June 21, 1999
JPN-99-020

Subject: James A. FitzPatrick Nuclear Power Plant
Docket No. 50-333
**Response to Request for Additional Information
Regarding ISI Program Relief Requests for
2nd Ten-Year Interval Closeout and Summary Report (TAC No. MA2019)**

**Response to Request for Additional Information
Regarding ISI Program Relief Requests for 2nd Ten-Year Interval
Closeout and Summary Report**

SUBJECT "B" RHR HX. Scanning Limitation For weld N-4B

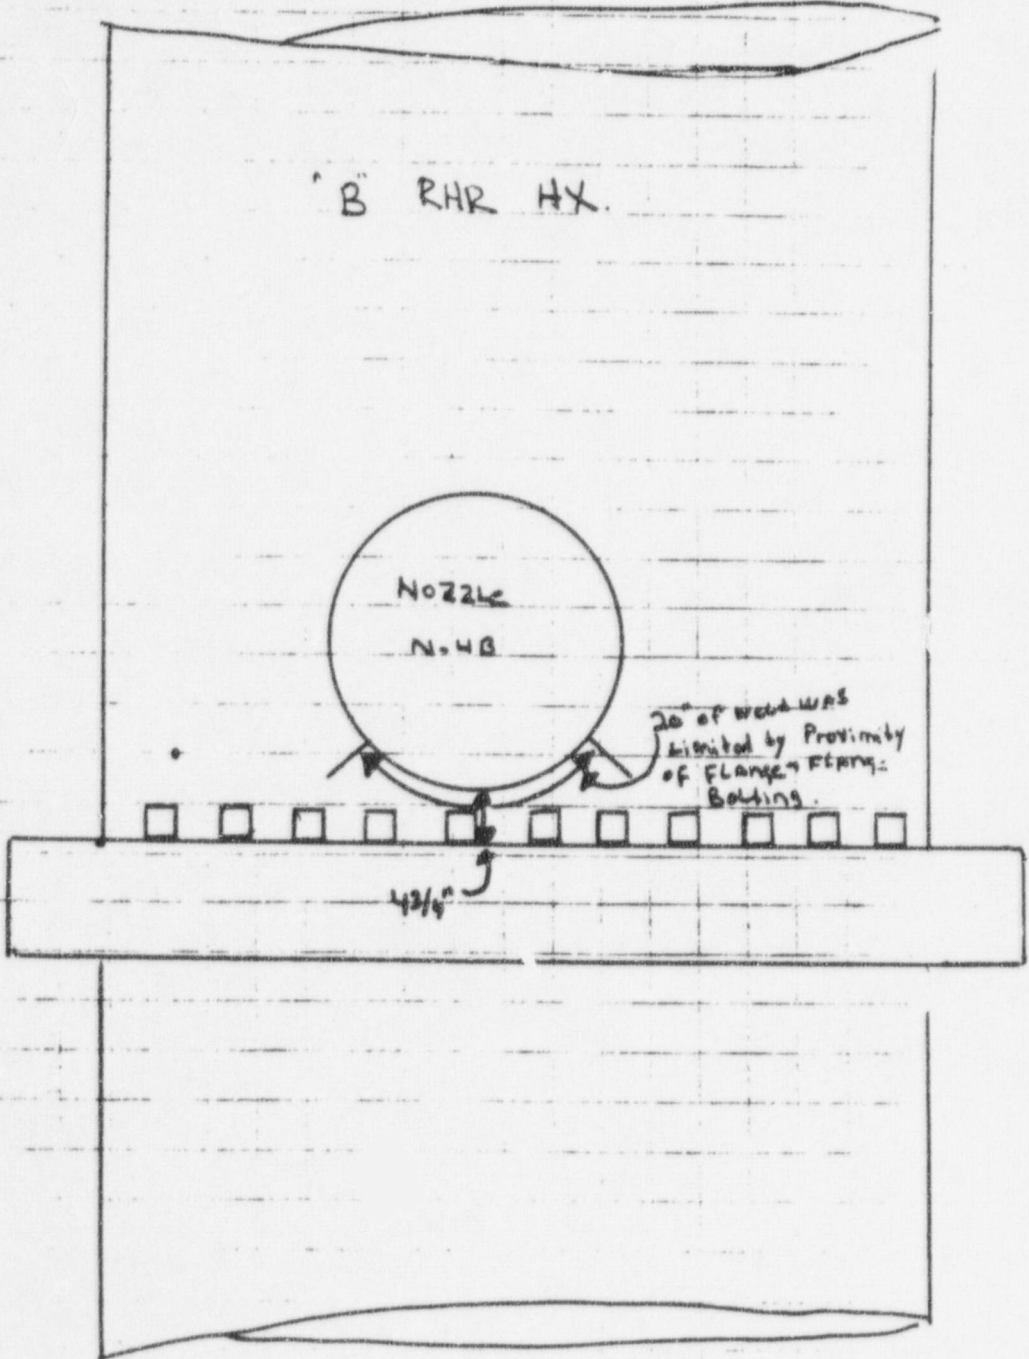
The licensee stated that the drawings and sketches included in Enclosure 14 of Reference 1 illustrate the restricted conditions encountered that limit examination coverage. It appears that Enclosure 14 includes only one drawing of the RHR Heat Exchanger. The drawing contains multiple welds and weld identifiers. However, the licensee drawing does not clearly identify the subject welds or the conditions limiting the examination coverage. Provide drawing, sketches, written description etc. which clearly identifies the subject welds and conditions limiting the examination coverage.

At FitzPatrick there are two RHR Heat Exchangers A and B, which each has two (2) Class 2 nozzles (4 total) for this Code Category. As shown on drawing MSK-3037, nozzles N-3A and B are located on the top head; and the other Class 2 nozzles are N4A and B which are on the vessel shell in close proximity to the shell flange. As shown on drawing MSK-3037, Detail "D", the configuration fit up for both welds only allows an effective ultrasonic examination for volume coverage to be performed from the shell side or head side. As an additional restriction, the N-4A and B nozzles, due to their close proximity to the flange and flange bolting, impeded examination coverage for approximately 20" along the bottom of the nozzle. In the case of the N4 nozzles both A and B were inspected to the extent practical during the 2nd Ten-Year Interval. Enclosed (Enclosure 1) is a full size drawing of the RHR Heat Exchanger along with sketches of the nozzles generated during examinations, which illustrate the restrictive conditions encountered during their inspections. The nozzles are also inspected by the VT-2 method each period during the pressure test required by Code C-H. No leakage has been noted.

SUBJECT N-4B "B" RHE HX Scanning Limitation

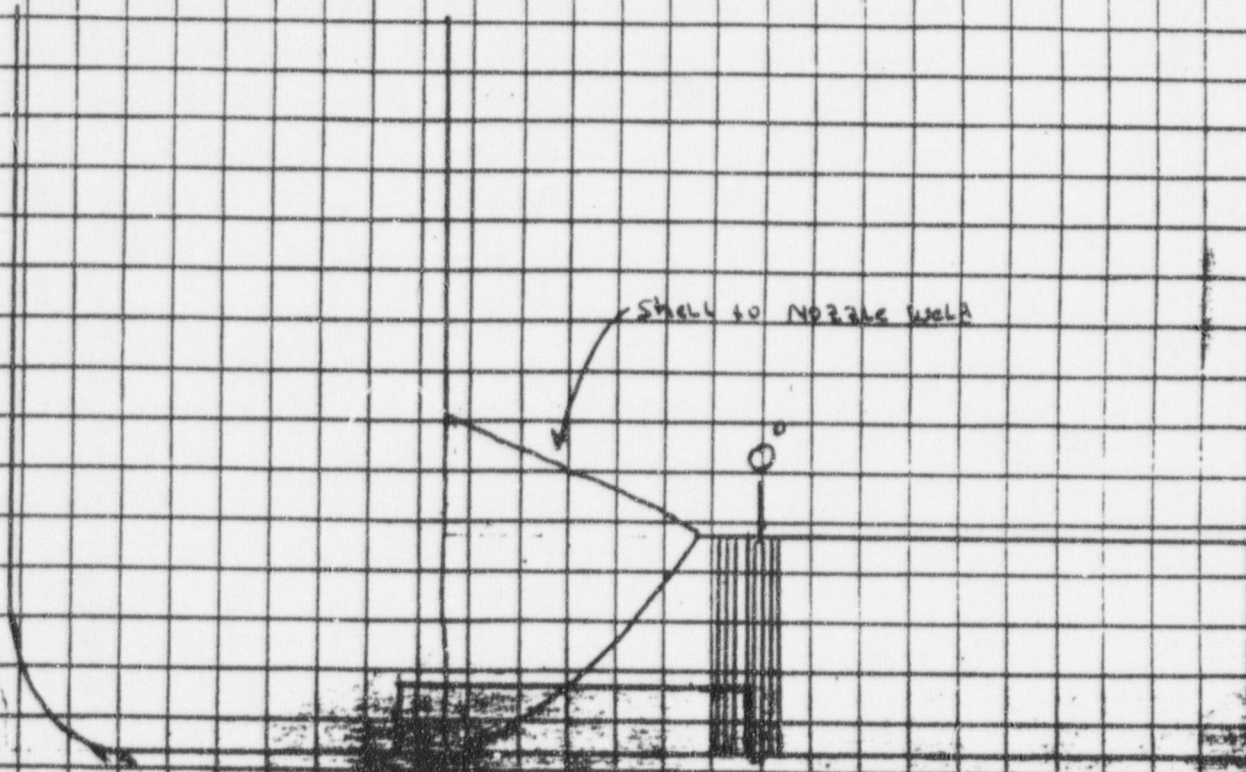
The Code requires 100% volumetric examination for the subject circumferential shell weld. Review of drawings submitted by the Licensee show that complete examination coverage was not possible due to restricted access caused by interference from the flange bolting and nozzle N4B. To meet Code requirements of the subject weld, removal of flange bolting and design modification of the heat exchanger nozzle would be required to allow additional access to the weld.

The Code allows for the required examinations to be distributed among the multiple vessels of similar design, size, and service. It is understood that complete coverage for the subject weld is impractical to perform due to interference from flange bolting and nozzle N4B. It appears to the staff that at FitzPatrick, two RHR heat exchangers exists. Please clarify why it is not possible to distribute the Code required coverage over the two heat exchangers as allowed by the Code.

At FitzPatrick there are two RHR Heat Exchangers, A and B. As shown on drawing MSK-3037 (enclosed), nozzle N4B is on the vessel shell in close proximity to the shell flange. The N4A and N4B nozzles, due to their close proximity to the flange and flange bolting impede examination of the circumferential weld. The area of weld examination coverage that could be performed for heat exchanger A would be identical to that of heat exchanger B. The same weld location would be inspected. The weld examination coverage can not be distributed between the two heat exchangers to obtain essentially 100% weld examination coverage for this reason. No leakage has been noted from either PHR heat exchanger circumferential welds.
